Subj: FIELD SAMPLING PLAN ADDENDUM AT CORRECTIVE ACTION PLAN SITES
04/19, 06, 14/22 15, 16, 20 AND 25 AT TREASURE ISLAND (NAVSTA TI)

Encl: (1) RESPONSE TO COMMENTS ON THE PHASE 2 SAMPLING FOR THE
CORRECTIVE ACTION PLAN SITES AT NAVAL STATION TREASURE
ISLAND

**RESPONSE TO COMMENTS ON THE
PHASE 2 SAMPLING FOR THE CORRECTIVE ACTION PLAN SITES
NAVAL STATION TREASURE ISLAND**

FIGURE 10
TOTAL TPH IN SOIL

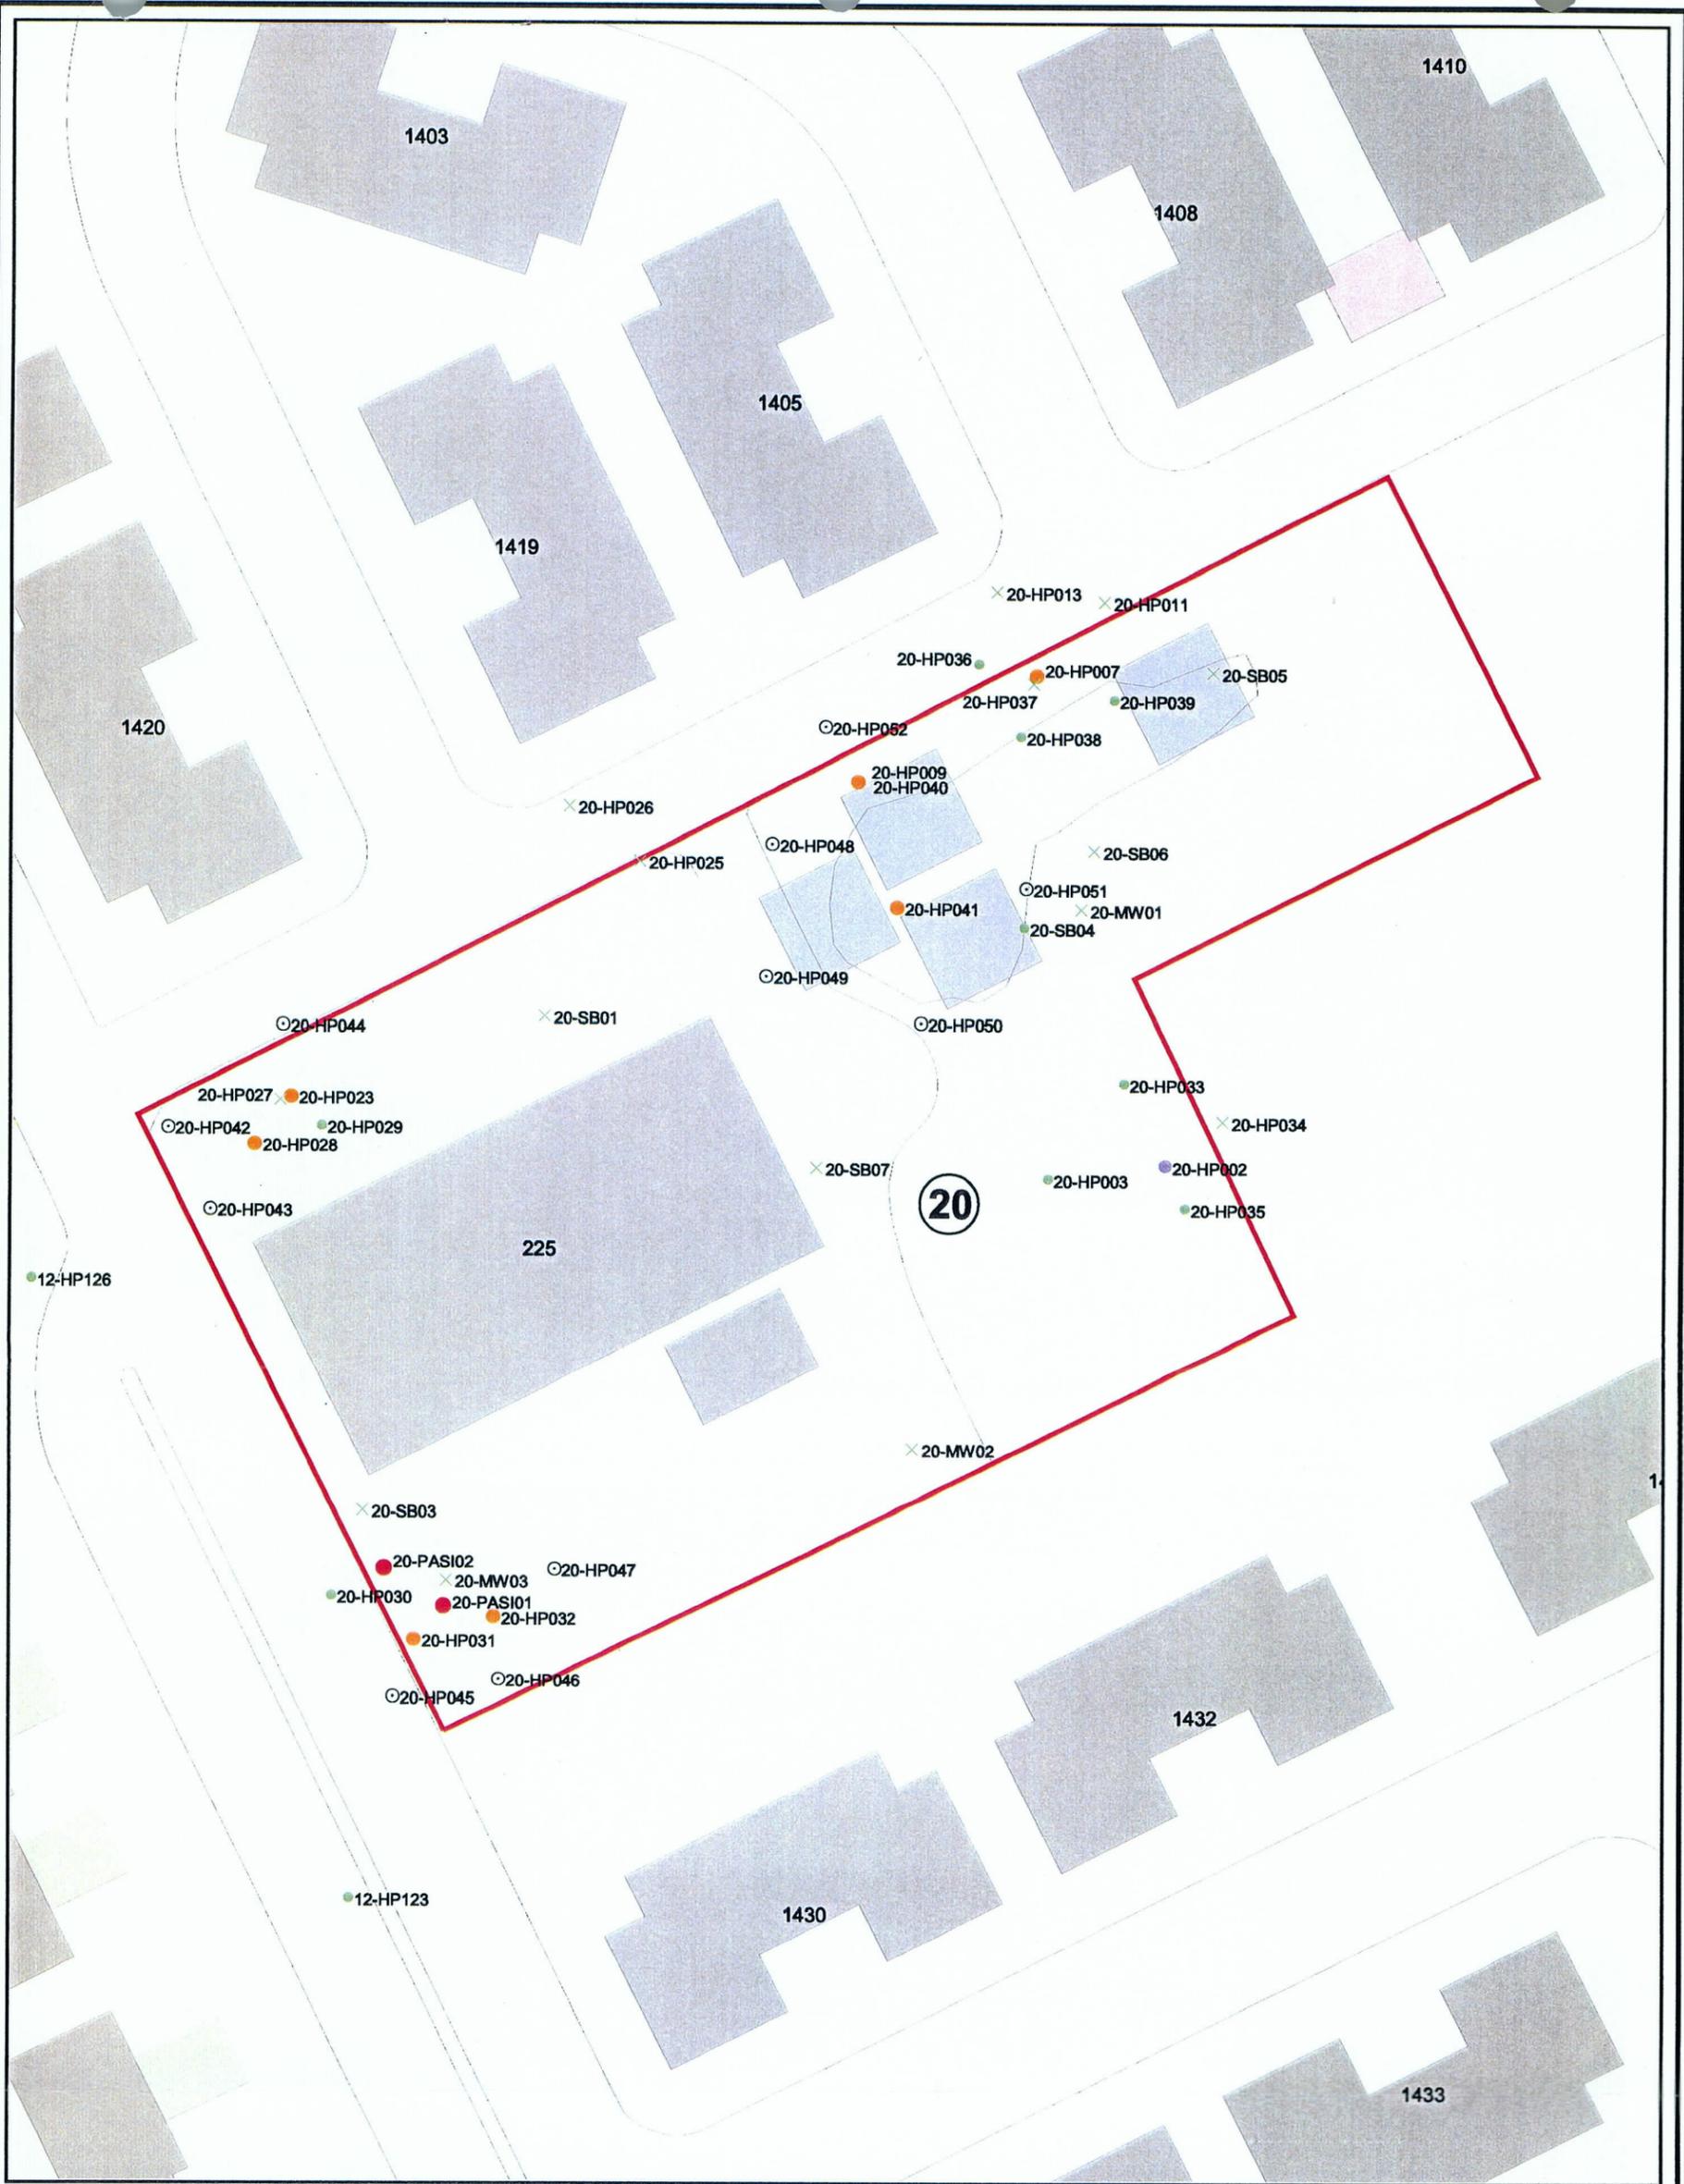
4. **Comment:** I suggest that we request the Navy to add a hydraulic-push sampling station, with collection and analysis of soil and groundwater samples for TPH and VOCs, west of Building 225, in the presumed downgradient direction. The sampling station should be approximately aligned with the long axis of the building and located a few tens of feet from the building, perhaps in the median of the street just west of the building. This sampling station is proposed because experience at other vehicle-maintenance and repair facilities indicates that the past use of Building 225 might have included the storage, use, and disposal of TPH and VOCs inside the building, but there are not sufficient data to directly assess contamination that might have originated in the building.

Response: The Navy will reevaluate the existing data for all of the CAP sites prior to proposing phase 3 sampling. The results of this data review will be discussed with the agencies and SFRA. A preliminary review of the Site 20 data supports the collection of additional groundwater data west of Building 225. This data could help distinguish between low concentrations of tetrachloroethene observed at boring 20-HP023 and at monitoring well 12-MW07.
